INDESIT company

Model type:
WT82EXP

Commercial code:
F026868

Notices

n1040245: Brembate washing machine basket doors re

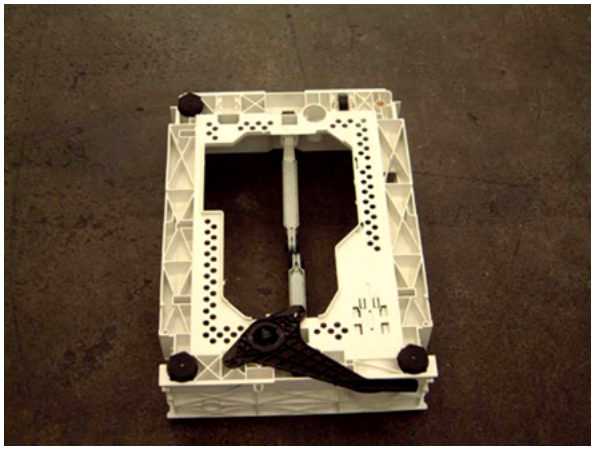
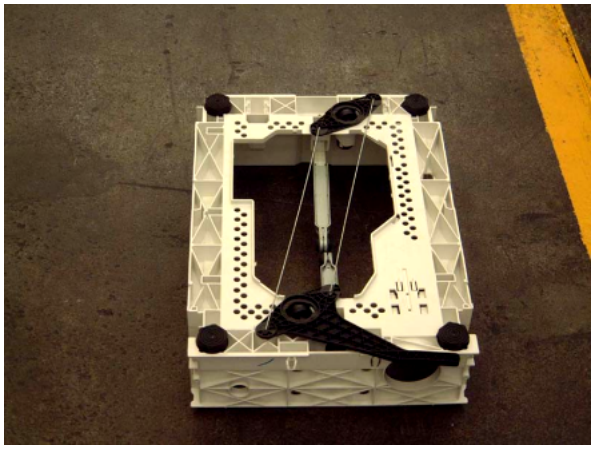
For all washing machine models produced in the Brembate factory and relevant to this note, in replacing the loading mouth code 083895/112743/252375 proceed as follows:
-remove the 18 rivets (9 on the right, 9 on the left) hooking the two doors to the loading mouth on the machine;
-take replacement part 083895/112743/252375 and carry out the same operation described in the previous point;
-hook the two new doors and the new loading mouth on the basket of the machine using the nut and bolts kit code 080691 (formed of 18 screws + 18 washers + 18 nuts);
-use silicone (SAT code 081629) for hooking the loading mouth on the basket.

FIG. 1

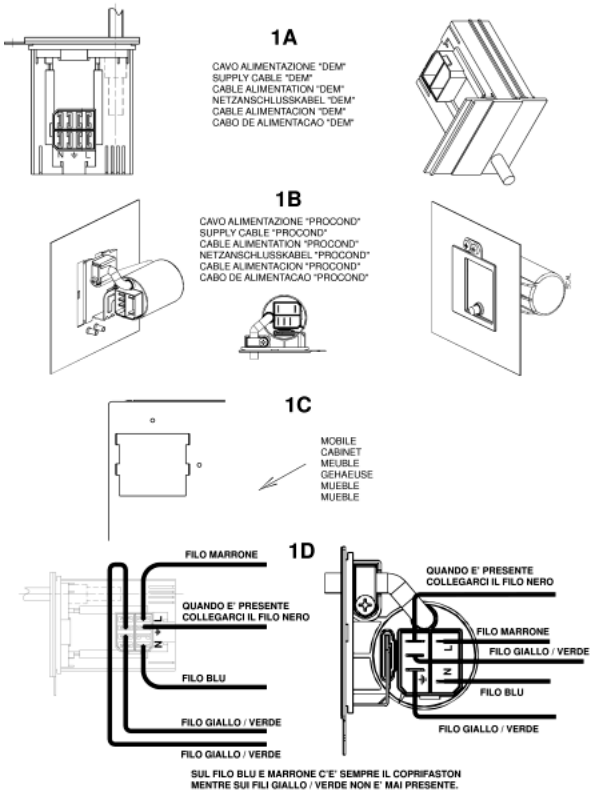
To use premodified wirings on modified products perform the connection to the terminal block of the new cable as shown in fig. 1 - 1D.
The wiring diagrams indicated in the Documentation remain the same.

FIG1 A

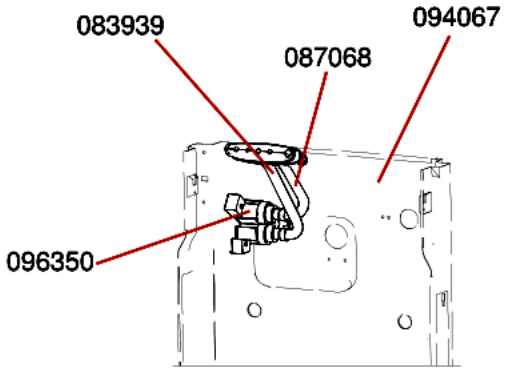
Replacement codes of the parts affected by this modification (see figure N1040309FIG1):

FIG1 A - PREMODIFICATION STRUCTURE
solenoid valve tube/distributor assembly: premodification 083939;
solenoid valve tube/distributor assembly: premodification 087068;
rear panel: premodification 094067.
FIG1 B - NEW STRUCTURE

FIG1 B

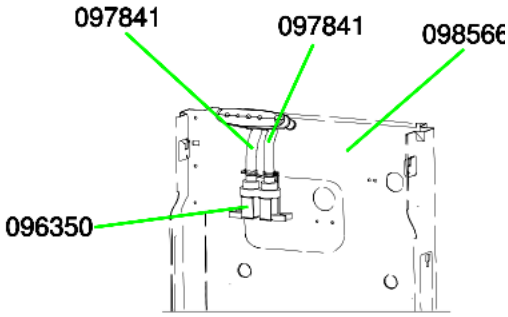
solenoid valve tube/distributor assembly: new 097841;
solenoid valve tube/distributor assembly: new 097841;
rear panel: new 098566.

N1040309FIG2

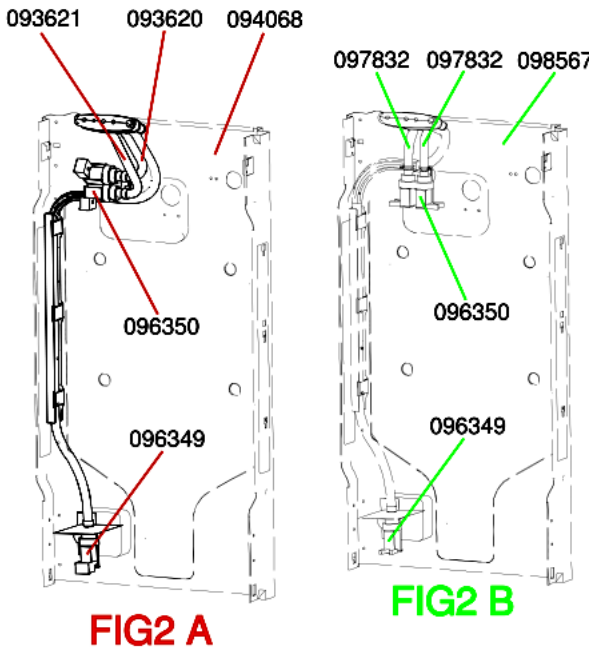
Replacement codes of the parts affected by the modification to WMTL80UK (see figure N1040309FIG2):

FIG2 A - PREMODIFICATION STRUCTURE
solenoid valve tube/distributor assembly: premodification 093620;
solenoid valve tube/distributor assembly: premodification 093621;
rear panel: premodification 094068.
FIG2 B - NEW STRUCTURE
solenoid valve tube/distributor assembly: new 097832;
solenoid valve tube/distributor assembly: new 097832;
rear panel: new 098567.

n1040321: Plastic protecion for solenoid valve.

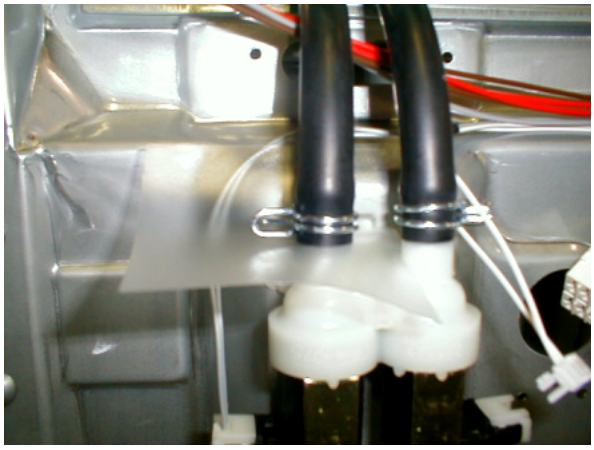
All top-load washing machines produced from September 2003 to February 2004 (from serial no. 30900.0000 to 40300.0000) have been equipped with a plastic protection Service code 109798 (shown in N1040321FIG1), to prevent water from damaging the solenoid valve and electronic card.

N1040324FIG1

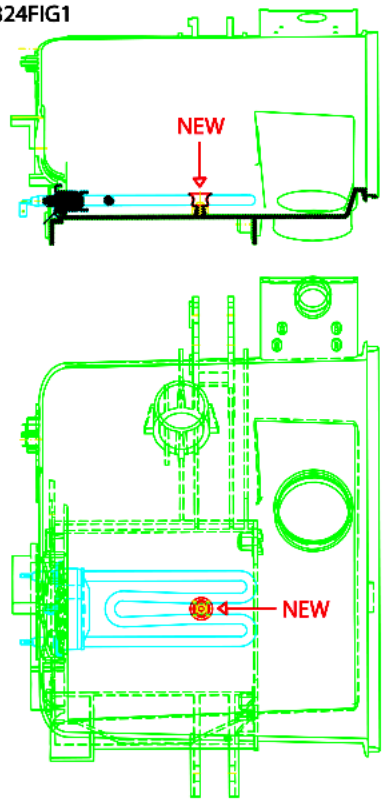
From serial number 40506.0001, the fixing system of the heater to the tank has been modified on all top-load washing machines affected by this note, with the introduction of a metal retainer (image N1040322FIG1 reference NEW) in place of deflector Service code 055322.

The modification has involved both heater and tanks. Given below are the Service codes of the new and old items concerned:

-PLASTIC TANK FOR 600-1000 RPM MACHINES: new 110152, premodification 083805;

-PLASTIC TANK FOR 1200 RPM MACHINES: new 110153, premodification 092023;

-HEATER: new 110148, premodification 083906.

N1040404FIG1

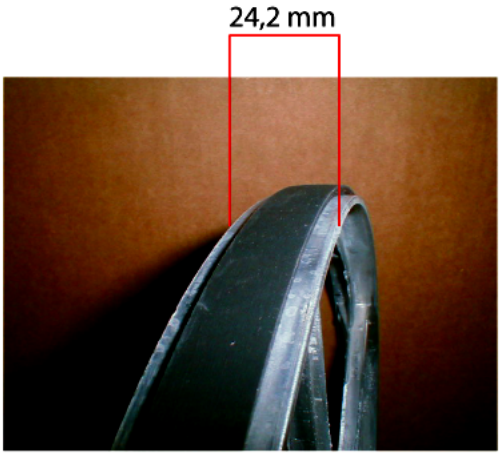
From serial no. 51202.0001 the pulley track has been widened from 21.2mm to 24.2mm (see picture N1040404FIG1).

new pulley
C00142832 - D280 24.2 mm track

Premodification pulley
C00083912 - D280 21.2 mm track

The new pulley can also be used on premodification versions of the models referred to in this release.
